HISTORIC PRESERVATION BOARD

AGENDA

WORKSHOP
ST. LUKE'S CATHEDRAL, 143 STATE STREET

TO: Chair Pollard and Members of the Historic Preservation Board
FROM: Rob Wiener, Historic Preservation Compliance Coordinator
DATE: August 6, 2021
RE: September 1, 2021 WORKSHOP – Preliminary Review of Proposed
Landscaping and Site Improvements
HPBR-001735-2021

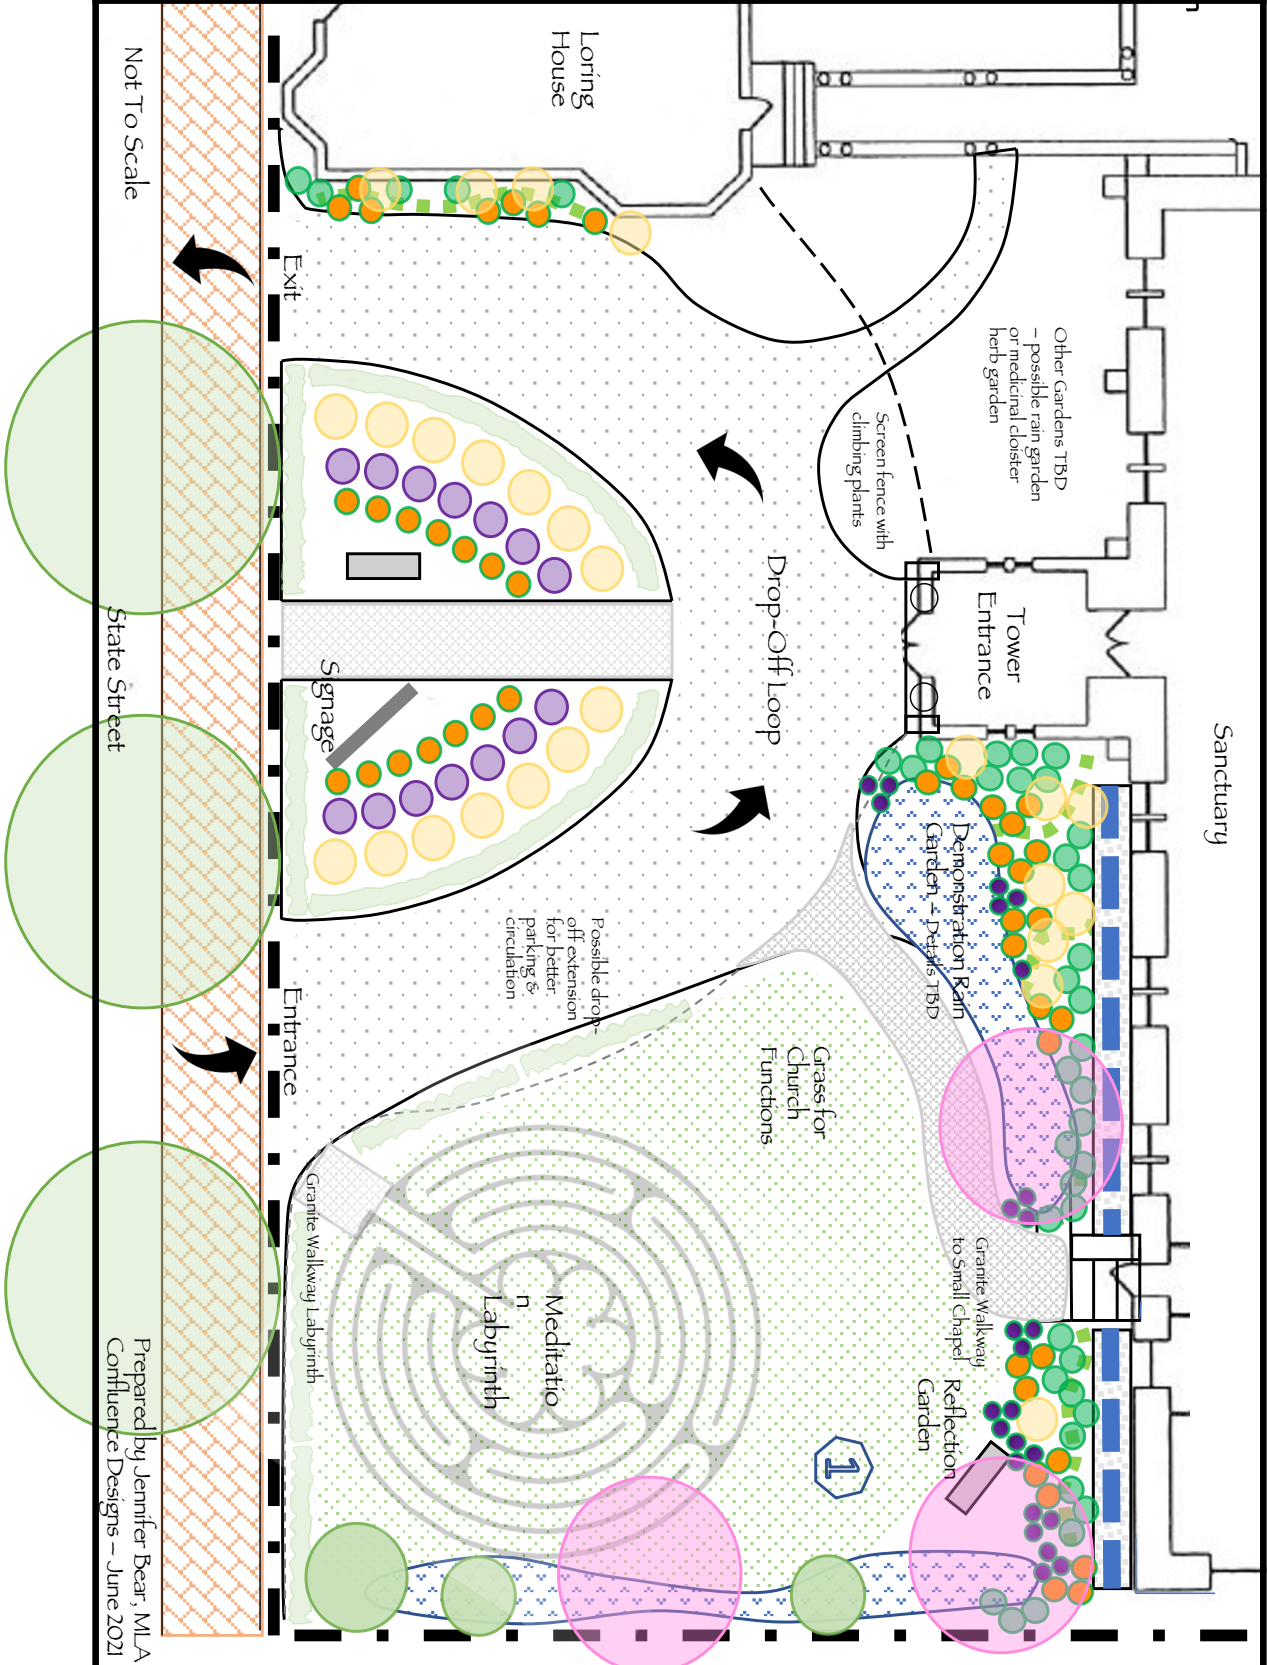
- It appears that most or all of the existing low hedges that help define the existing landscape are being retained, and are included in the new plan.
- Two benches are indicated on the site plan, one in the central garden near the entrance walk, and one set back in the reflection garden. No details have been provided at this point, except that one new bench will match an existing style.

- The St. Luke's sign is to be moved to make room for the labyrinth, to a spot near the entrance walk. Ms. Bear expressed a desire to organize and consolidate the additional signs and banner that can proliferate to mark seasonal and other messages.

- A note mentions the possible extension of the edge of the circular drive on the southeast side, to make parking and circulation easier. This would necessitate relocation or removal of the existing hedge, but Ms. Bear said the hedge would be maintained between the labyrinth and the drive.

ST. LUKE'S CATHEDRAL - Labyrinth Conceptual Design (Phase I)

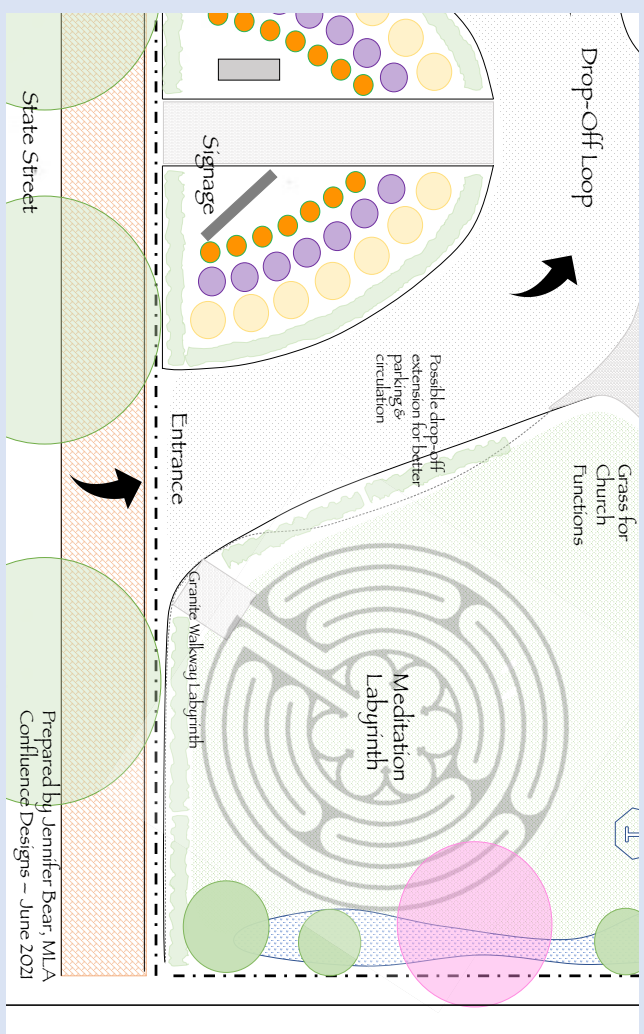
Please see the summary letter provided by Ms. Bear. Staff notes that several features in the design have yet to be developed, and will be part of the future phase of improvements. Other details may depend on pricing and budget, and on the Board's feedback – especially the particular details of the labyrinth, which is the first priority as Phase One.

- The path to the small chapel in the southeast corner is proposed as a native Maine granite walkway. Ms. Bear told staff the granite will be sourced from Millenium Granite in Wells, and will be rectangular pieces for paths, with a surface rough enough for traction. The quarry offers two colors: a grey stone, and a grey that is slightly pinkish; Ms. Bear hopes to show samples by Zoom.

- Granite pieces for the labyrinth and the walk are to have slightly eased corners, according to Ms. Bear.

01 North Elevation
 Scale: 1/4" = 1'-0"
 0 1' 2' 4' 8'

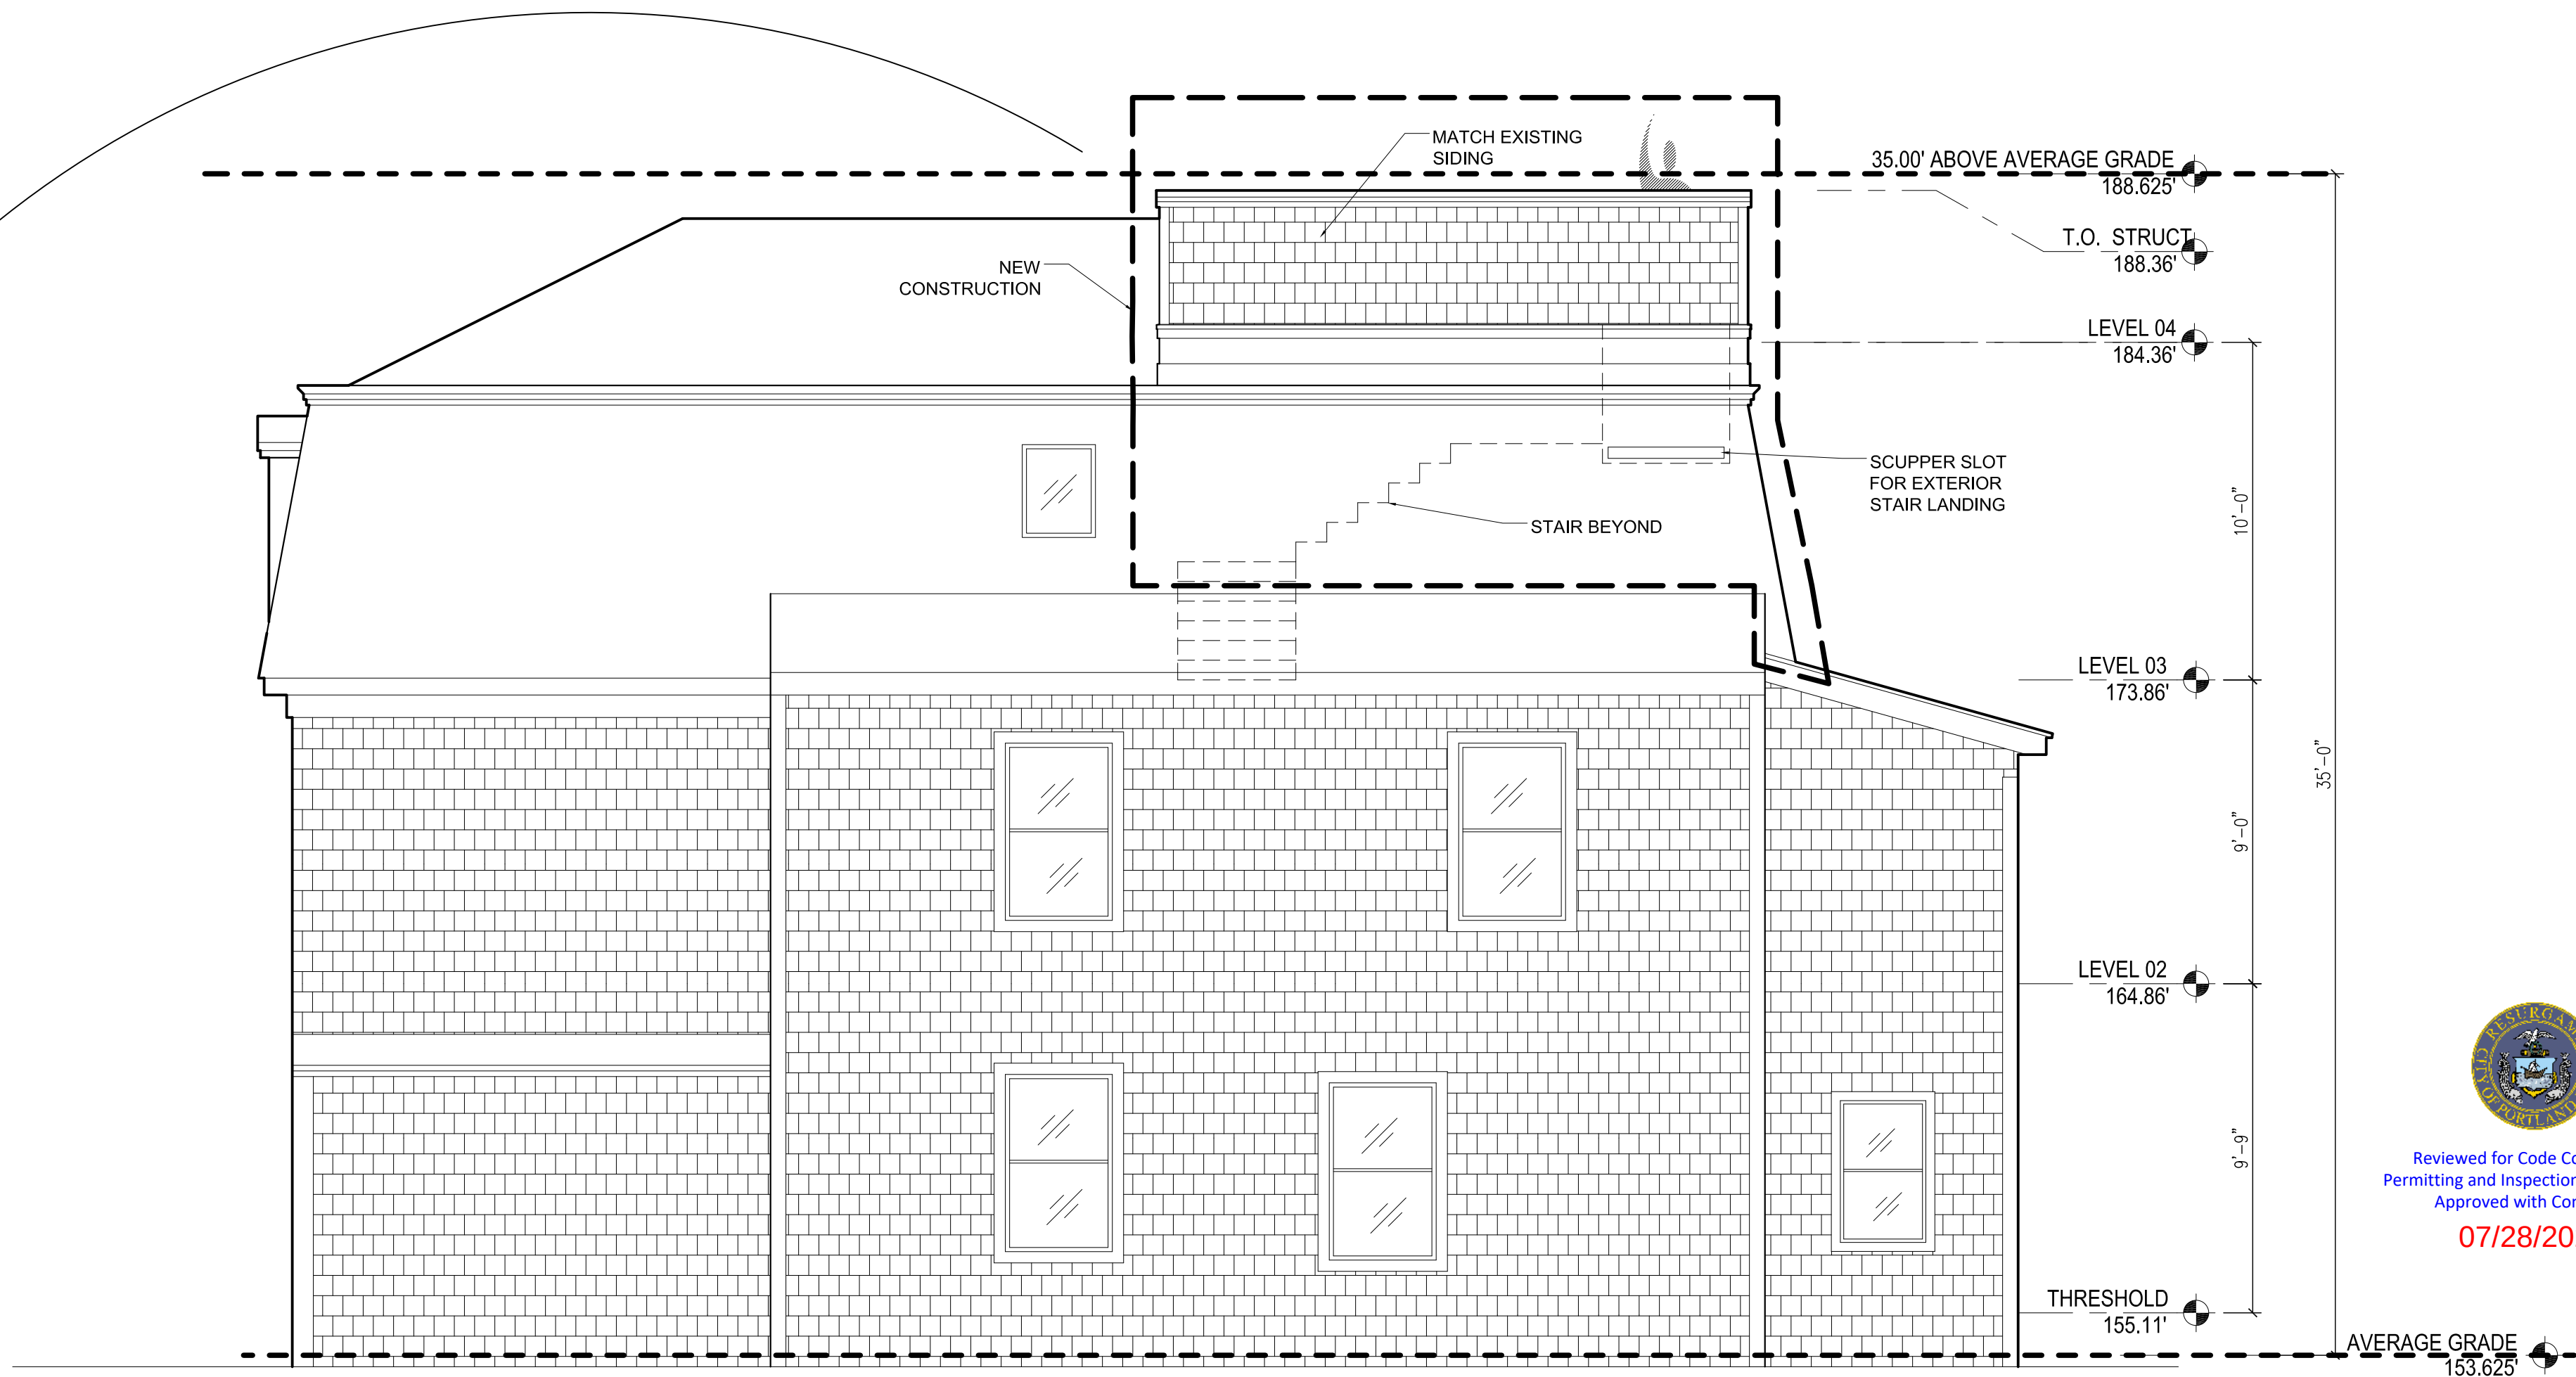
- The front portion of the house that is capped by the mansard roof is only two bays deep, but we don't know the history of the structure's evolution.
- Questions were raised as to whether extending the mansard to the end of the third floor and replacing the rear shed would create the false impression of an original four-bay-deep mansard roof. Could or should the extension be subtly distinguished through details, to convey the much later date of construction and avoid creating an impression that might be based on conjecture?

- It was noted that the lower floors currently appear to extend seamlessly, despite the change in roof form, but again, we do not know the history.
- At least several Board members said they could support the extension of the mansard, even if it did not prove feasible to design a jog in the roof that would distinguish the newly added section.

The applicant's desire to expand the building at the rear to accommodate another unit on the third floor has prompted the question of how best to treat the roof form. The proposal to extend the mansard roof form over the rear bays of the house calls into question the applicability of Standard # 3, which discourages "alterations that have no historical basis or [which] create a false sense of historical development". In this case, we have no documentation to confirm this area of the building once featured a mansard roof, although other visual cues suggest this might have been the case. Extending the sloped portion of the mansard would, however, remove the clearly incompatible shed roof and create greater visual consistency. In staff's view, this would be an acceptable direction to take. Perhaps subtle distinctions in treatment, such as eliminating the brackets and dentils at the cornice line, would help distinguish the "original" roof from the extension.

- The added dormer in the extended south mansard has been moved toward the rear, to align over the rearmost lower windows, so that the three south dormers (two of them original) would not be equidistant from each other.
- The south edge of the deck has been pulled back from the edge of the roof by one foot, which the applicant hopes will address Board concerns about the visibility of the deck and its railing. (Note: The relocation of the railing and deck edge is correctly depicted in Detail 01, Framing Cross-Section on pg. S2, but the move is not reflected in detail 01 on page A5, or in Elevation 03 on page A4.)
- The deck railing is no longer specified as cable rail, and is shown on page A5 as a more traditional balustrade, though details are still indistinct, with a note that says "final product selection to be by the owner."

04 South Elevation
Scale: 1/4" = 1'-0"

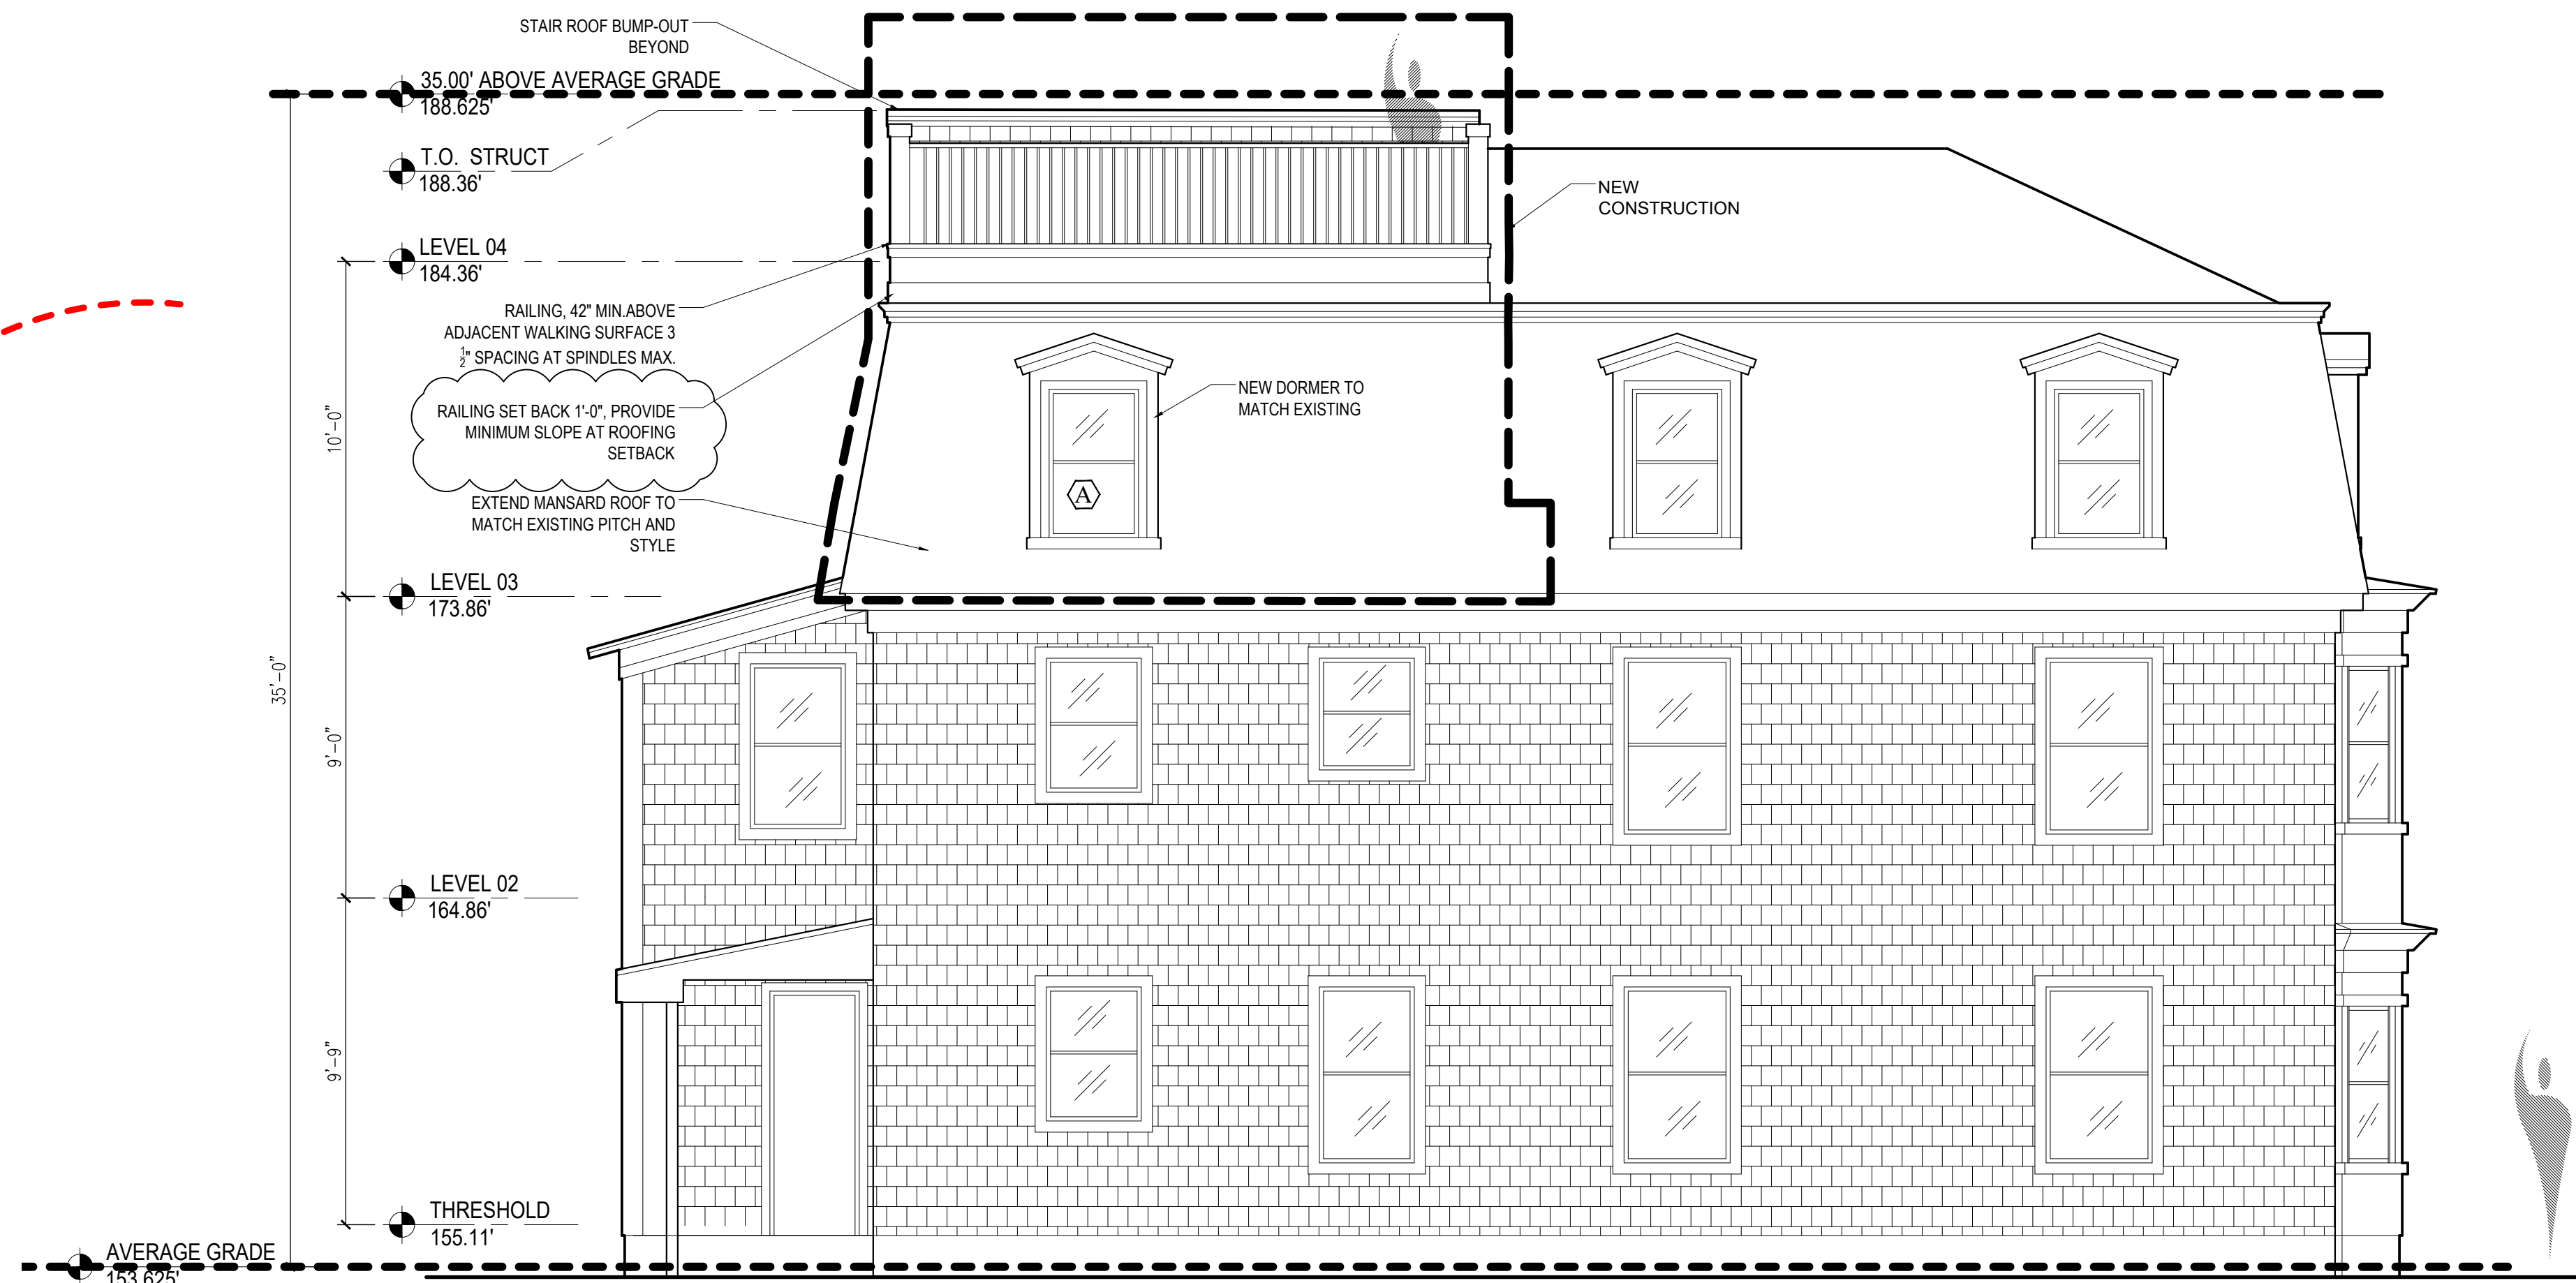
- As staff noted, the enclosed access stair would be higher than the ridge of the upper front roof, which is hipped. Also, the railing for the deck would extend above the south roof plane. In both cases, Board members asked whether visibility of the new features could be reduced.

Regarding the applicant's proposal to add a roof deck and stair tower on top of the extended mansard, it could be argued that these added elements undermine the consistency achieved by extending the mansard, and reintroduce a level of visual complexity at the building's rear roofline. On the other hand, these interventions are set well back from the street. Although visible, the location makes them less prominent. In evaluating these changes, Board members should consider the degree to which they will impact the building's overall historic character. Like many houses on Munjoy Hill, 42 Lafayette Street has been altered over time to accommodate changing needs. The question for the Board is whether the proposed alterations, in sum, are generally compatible with the historic structure.
